PLANT NAME: H. B. Robinson, Unit # 2

NG-73-163

H. B. ROBINSON UNIT NO. 2
LICENSE DPR-23, DOCKET NO. 50-261
ADDITIONAL INFORMATION IN SUPPORT OF
100% THERMAL POWER AUTHORIZATION

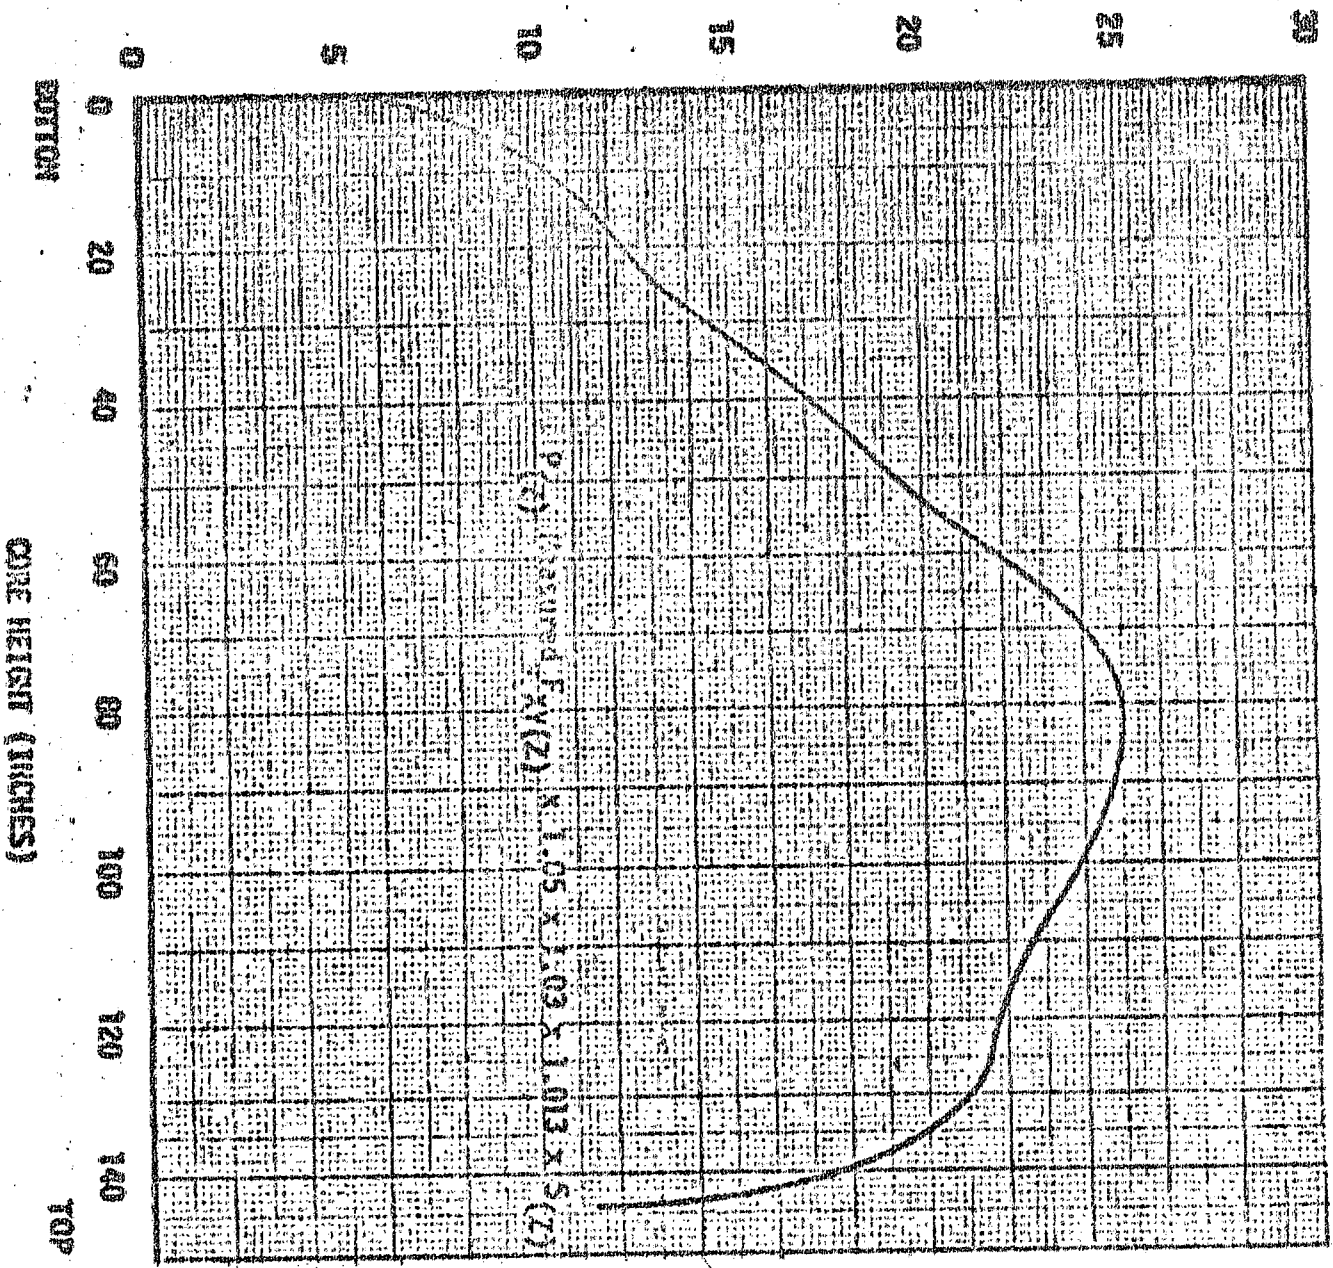
The power shape analyzed is shown on Figure 1 as a plot of F_q versus core height. As shown on the figure, allowances have been made for the effect of pellet density variations (1.013) and the power spike penalty appropriate to a region with flattened clad sections. Additionally, the measured values for the radial peaking factor, F_{xy} , as a function of axial height have been included in this figure. The peak linear rod power corresponding to this power shape is 13.8 kw/ft.

FIGURE 2

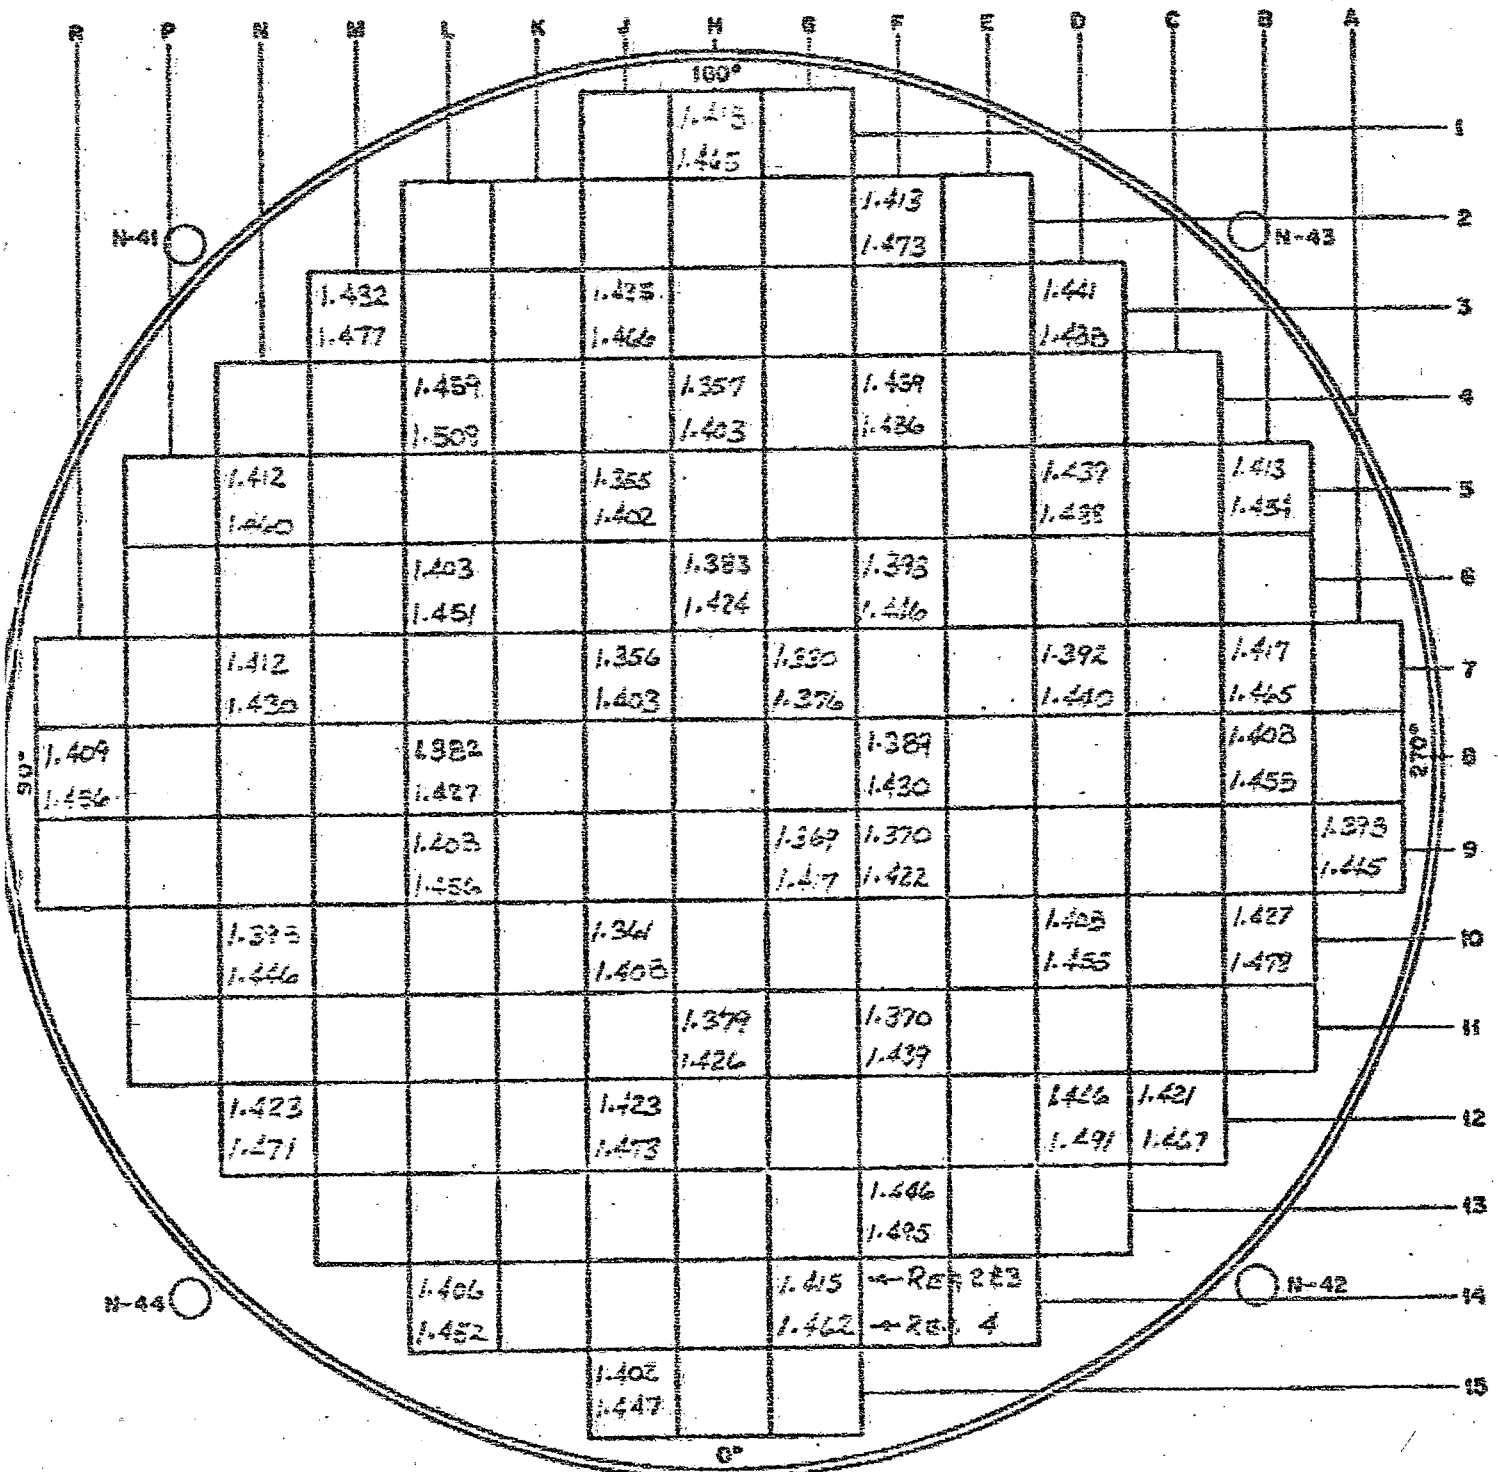
Values of \bar{K} , the factor relating a specific thimble F_z to the region F_N and the associated standard deviation for each \bar{K} were determined and are illustrated in Figures 2 and 3. The values of \bar{K} presented shall serve as the initial values for the conduct of the surveillance program subject to the continued accuracy conditions set forth in 3 above. Likewise the standard deviations contained in Figure 3 serve as the initial bases for thimble selection and the associated uncertainty to be used during surveillance.
